STATE OF NORTH CAROLINA
DEPARTMENT OF TRANSPORTATION

Subject: **Amendment to the Application for a Regional General Permit 198200031 and Section 401 Water Quality Certification for TIP R-2408A**, the proposed improvements of SR 1323 (Riverview Street) from the intersection of Iotla Street to NC28 in Macon County. NCDOT Division 14. Federal Project No. STP-28(1), State Project No. 8.1970801.

Permit Drawing
Sheet 3 of 13
Revised 10/5/2007

Permit Drawing
Sheet 5 of 13
Revised 10/5/2007

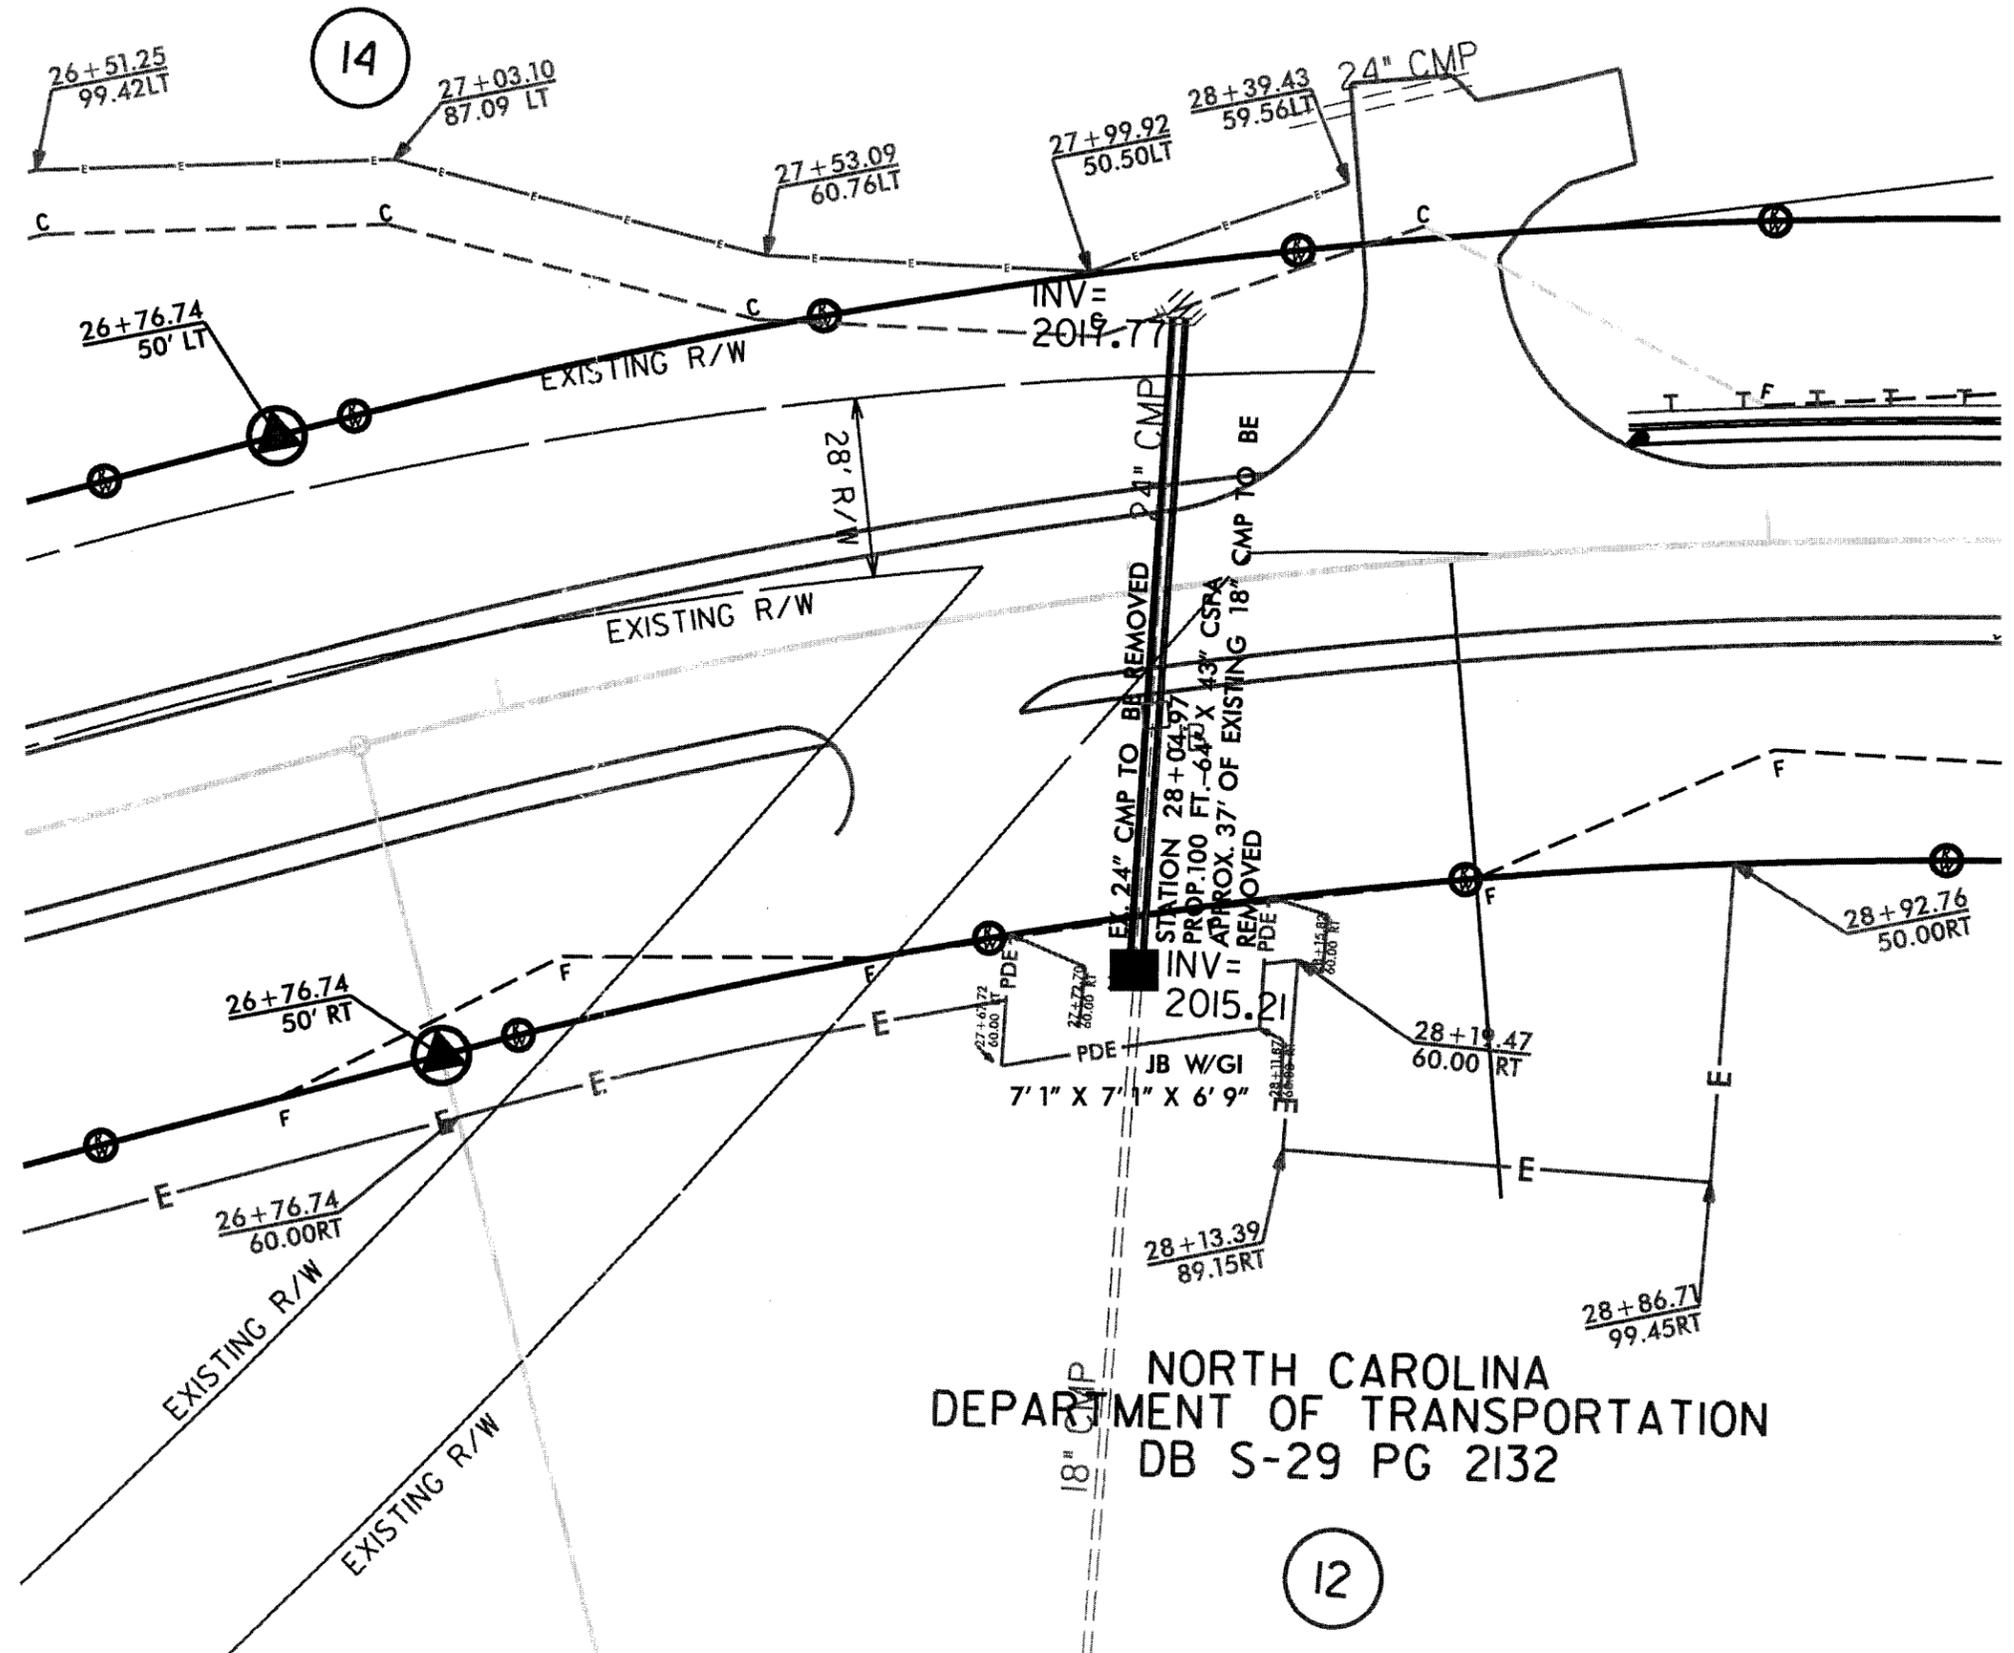
Due to re-evaluation of the removal of the attached 18-inch pipe connected to the junction box, NCDOT will remove only 37-feet of the existing 18-inch pipe at this time, to accommodate the new, longer 64-inch metal arch pipe. The new 64-inch pipe will be connected to the 18-inch pipe at a junction box. Hydraulic information concerning the junction box is contained on Sheet 7 of the plan drawings. No additional impacts will occur due to the revision of this site. Due to time constraints, NCDOT will remove the junction box and the remaining 18-inch pipe and restore the stream using natural stream design techniques at a later date. NCDOT will propose to use mitigation credit from this site for the B section, which is a separate permit application.

Permit Drawing
Sheet 11 of 13
Revised 10/5/2007

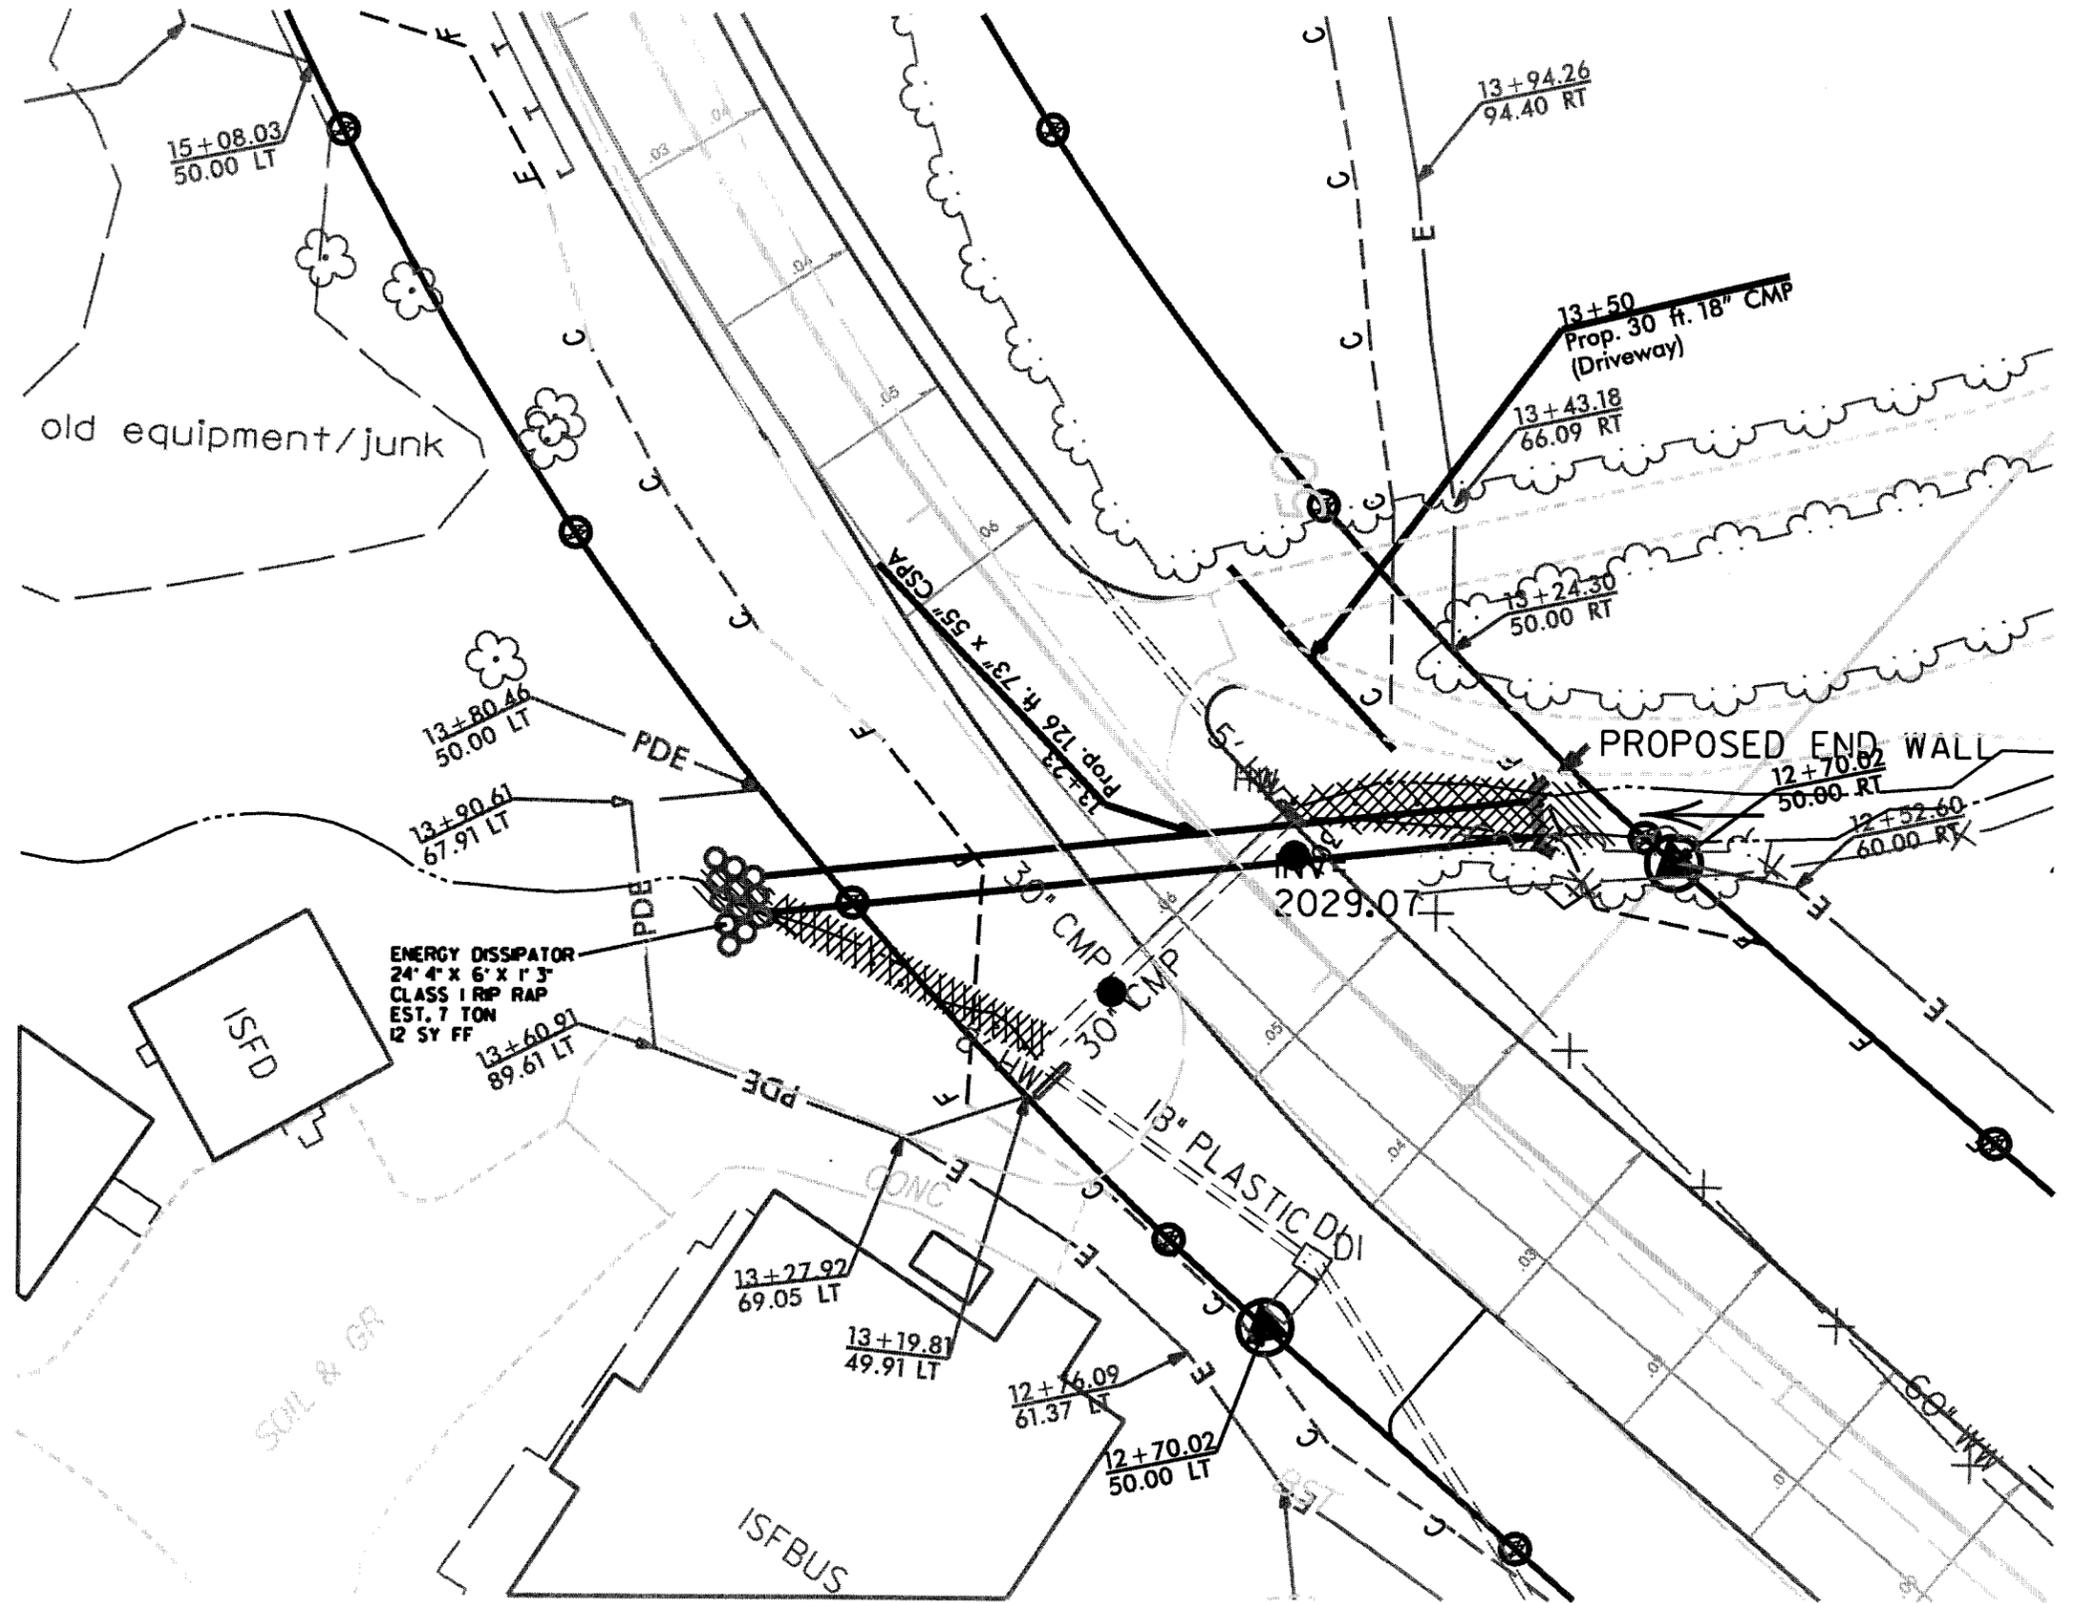
Previous plan drawings of the cross section of the placement of the new 75-inch x 55-inch metal arch pipe erroneously showed that the pipe would not be buried below the stream bottom. Revised drawings of this site show the new pipe being buried at least 12-inches below the stream bottom (Sheet 13). This will allow natural stream bottom materials to become established following installation and provide aquatic passage during periods of low flow. Because of the slope of the new pipe (<6%), a dissipater pad will be installed on the downstream side of the pipe (Sheet 11). The addition of the dissipater pad will cause an increase of 24 feet of permanent impacts to this site. Permanent impacts at this Site 3 will increase to 124 feet.
